ADDENDUM NO. 1
TO
PLANS AND SPECIFICATIONS
FOR
PROJECT NO. E030277-B
Requisition No. _____

DESCRIPTION OF PROJECT: WATERWORKS IMPROVEMENTS
LOCATION: CHAIN O' LAKES STATE PARK – NOBLE COUNTY,
IN
ISSUE DATE: JANUARY 21, 2015
INDIANA STATE AGENCY: DEPARTMENT OF NATURAL RESOURCES

BY-PASS PIPING FLOOR PLAN

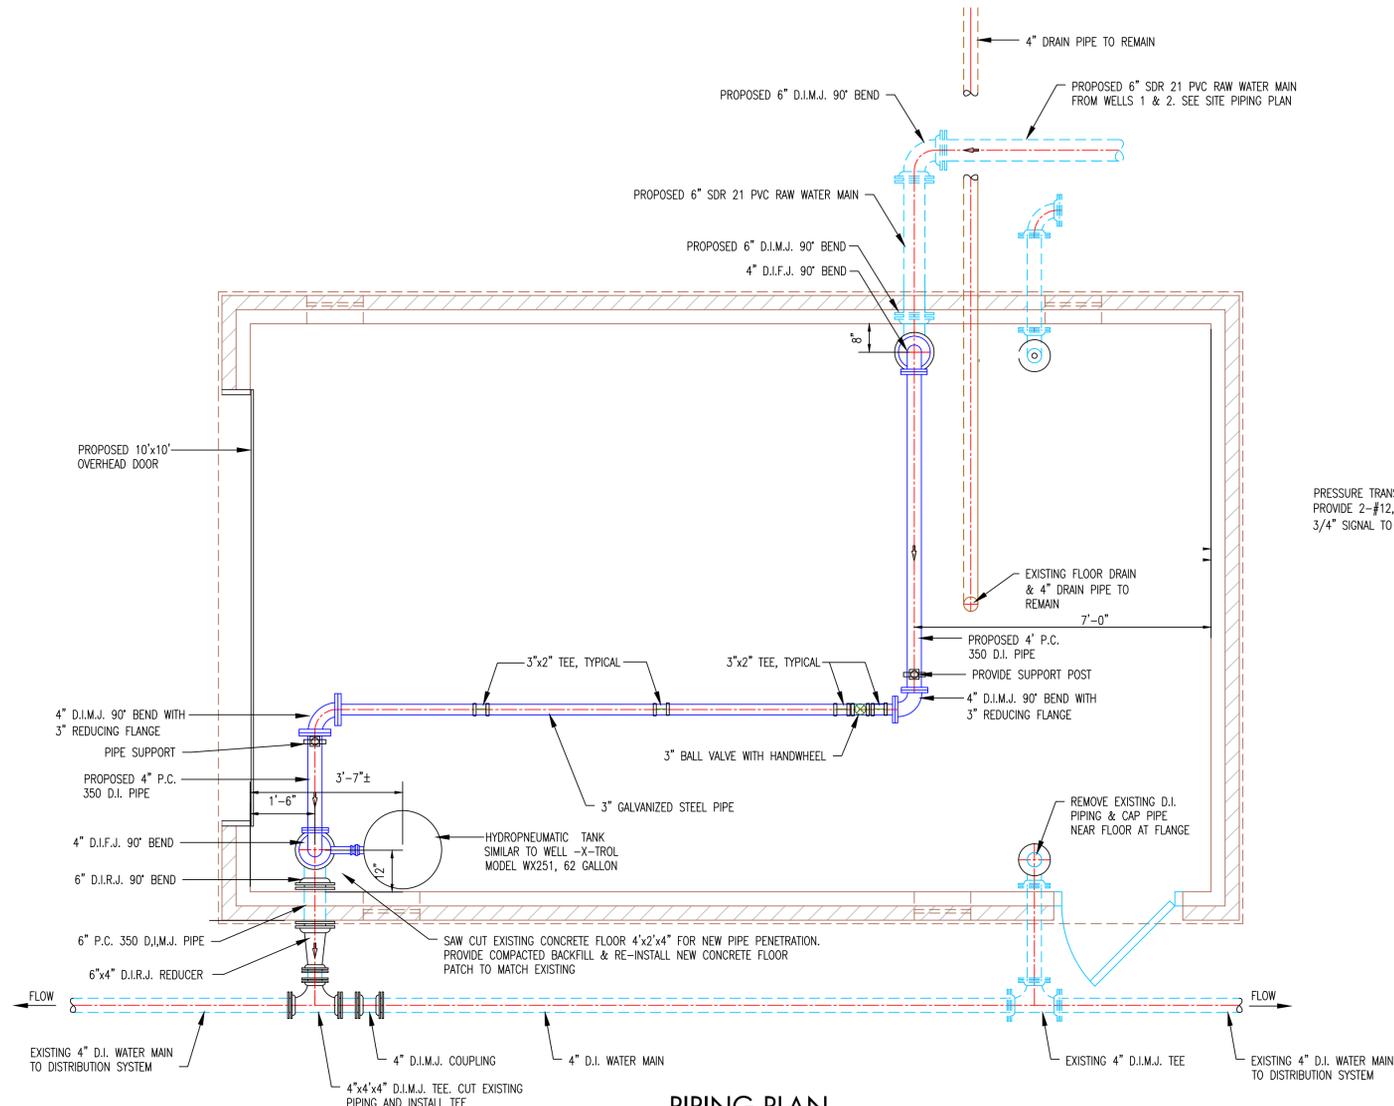
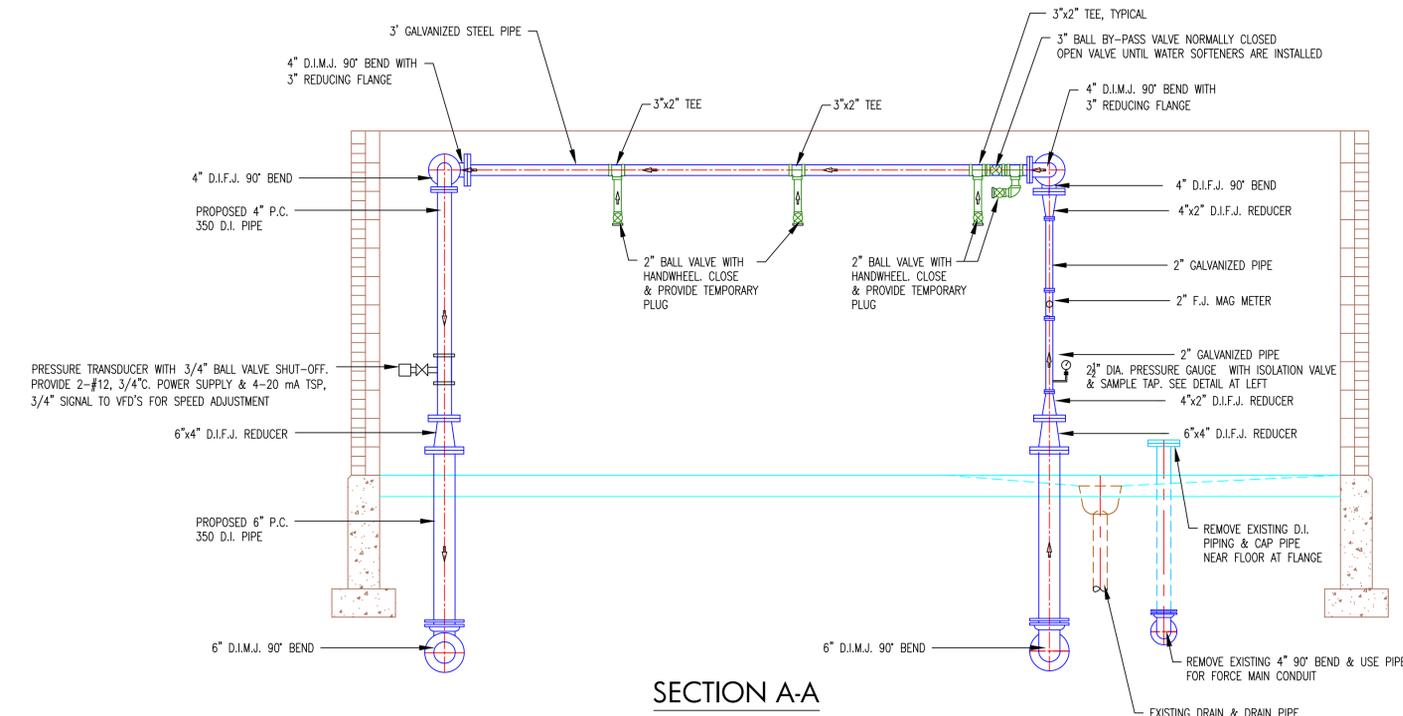
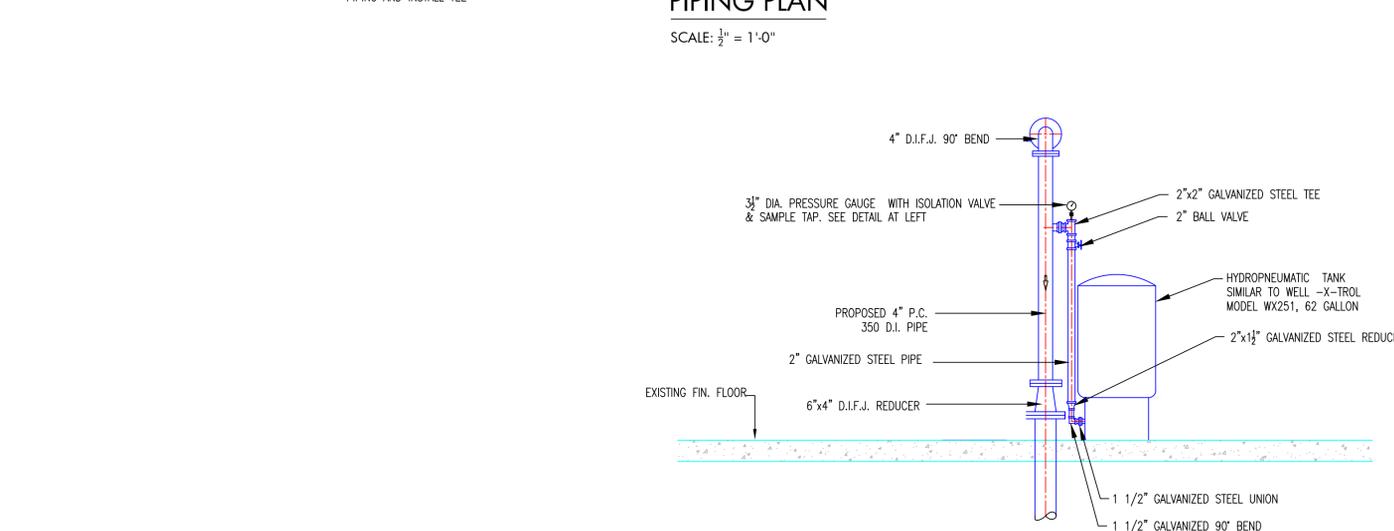
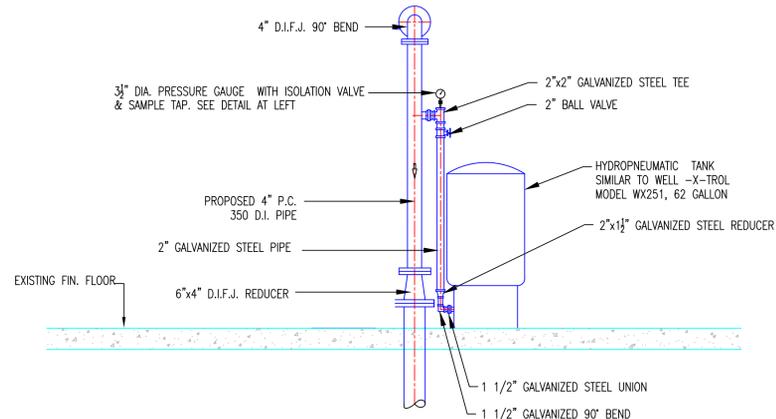
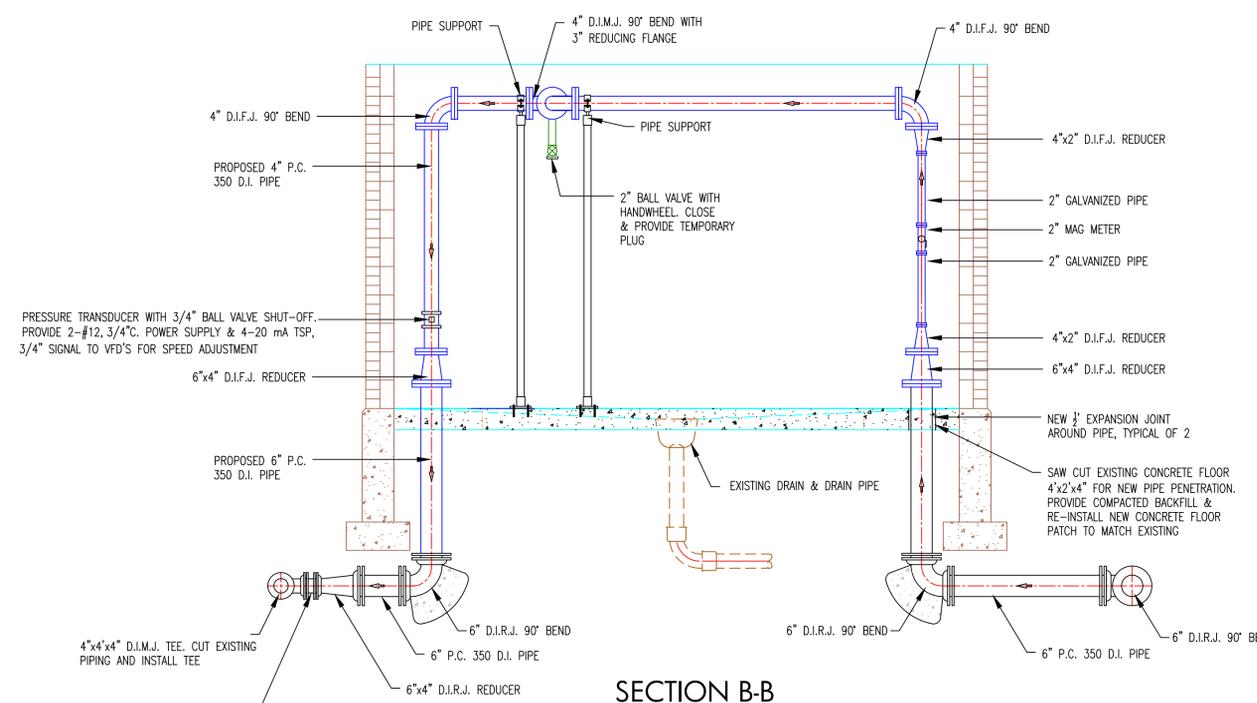
Attached drawing numbered 5A of 8 shows the piping that Contractor shall construct to achieve by-pass piping until water softeners can be placed in service. The initially installed by-pass piping and pressure tank shall be totally utilized as an integral component of the permanent project piping
